FSN 72800620

**URGENT - Field Safety Notice  
Medical Device Correction**

**Ingenuity CT, Ingenuity Core, Ingenuity Core<sup>128</sup>  
With Continuous Computed Tomography  
(CCT) Option and have been Upgraded from  
Software Version 3.x to Version 4.0.0 / 4.0.1**

**Protocol Conversion Resulting in Delayed Images when using CCT Option**

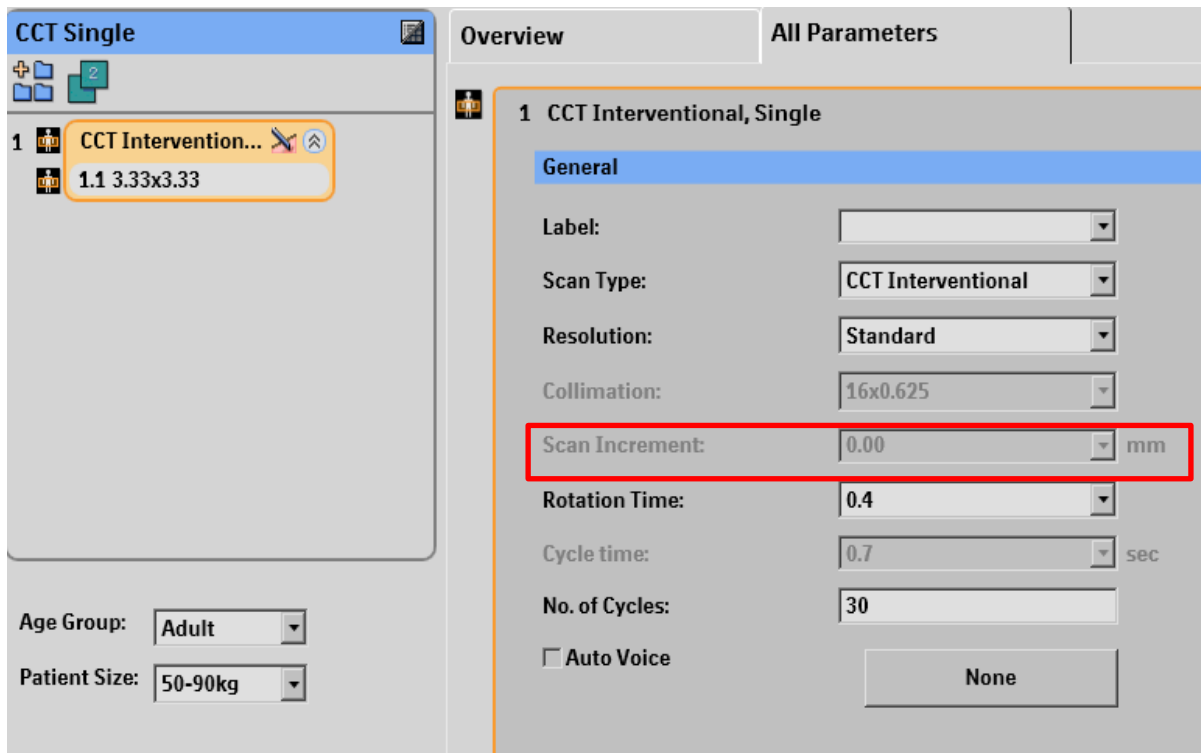
5. Double-click to open the CCT **Exam Card**.
6. Exam cards having the issue will have slice thickness and increment that do not match when opening the exam card. Please see example below:

- Also note that when the acquisition step in the exam card is selected, the scan increment should be 0.00.

- If the exam card has a mismatch, it is recommended to rebuild the CCT exam cards from the reference CCT exam cards.
